Technical Bulletin

Subject: **Toothed Belt Runs Towards Outside, Wears Out, Jumps Off, Cracks**

Number: **97-01**

Model(s): **Golf, Jetta, Passat
with 1.9L (Engine code AAZ, 1Z) 1994 ► 1997**

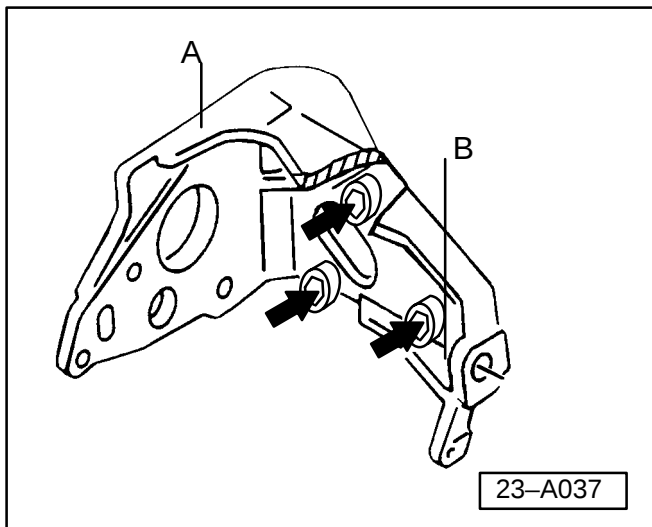
If belt protrudes beyond face of crankshaft sprocket, adjust Diesel Injection pump mounting bracket as follows:

- Remove injection pump.
- ◀ Slightly loosen three fasteners securing bracket to engine –arrows–.
- Press bracket down at point –A– and lift at point –B– while a second Technician torques fasteners –arrows– to 25 Nm. (18 ft. lb.).
- Reinstall injection pump.
